AMENDMENT NO. 3 DECEMBER 2005
TO
IS 2692 : 1989 FERRULES FOR WATER SERVICES —
SPECIFICATION

(Second Revision)

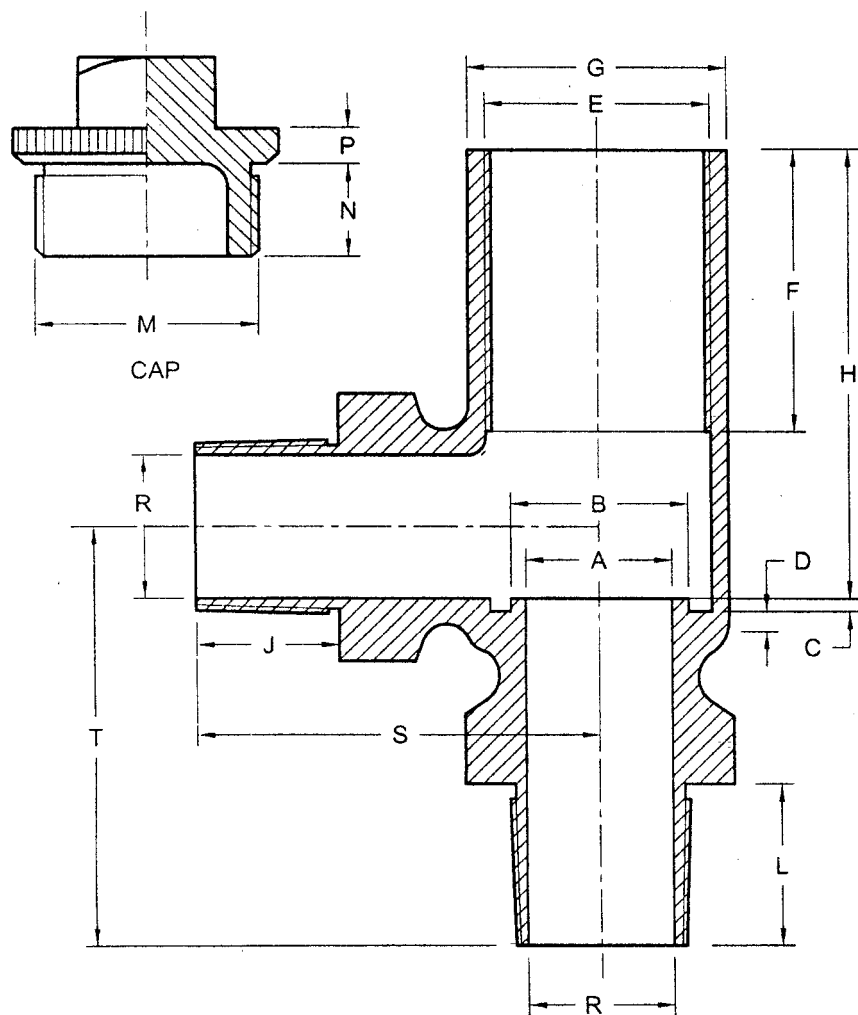
(Page 3, Table 2) — Substitute the following for the existing figure:

FIG. 1 ILLUSTRATION OF A TYPICAL FERRULE

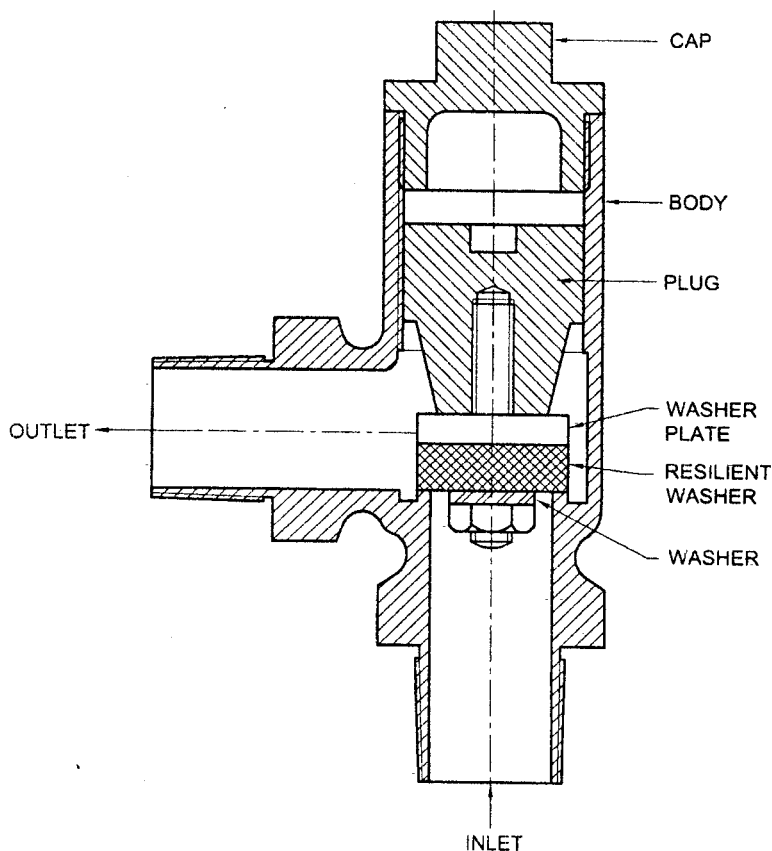
(Page 5, Fig. 1) — Substitute the following for the existing:
